3.0 **Existing Landslides**

3.1 Overview

Figure 1: Landslide Locations along the P2Wk Alignment

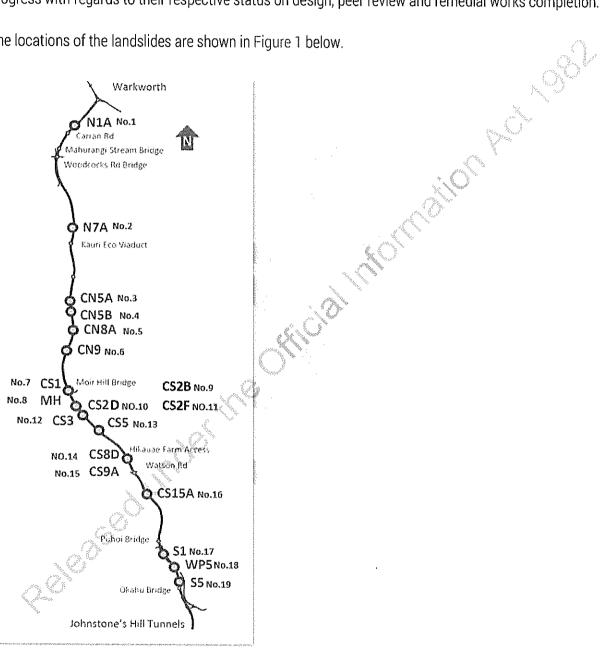
The followings risk items have been identified:

Soil slope failures, predominantly failing along the soil rock transition zone, ø

- Topsoil slumps and surficial erosion,
- Softening of ground (soil, weathered rock, fill) caused by groundwater seepage or surface water run-off,
- Surficial failure rock slopes and rockfall behind mesh draping,
- Wedge failures at rock slopes between rock bolts or at location without rock bolts,
- Scour/erosion and debris flow from soil slopes or soil-rock interface above rock slopes.
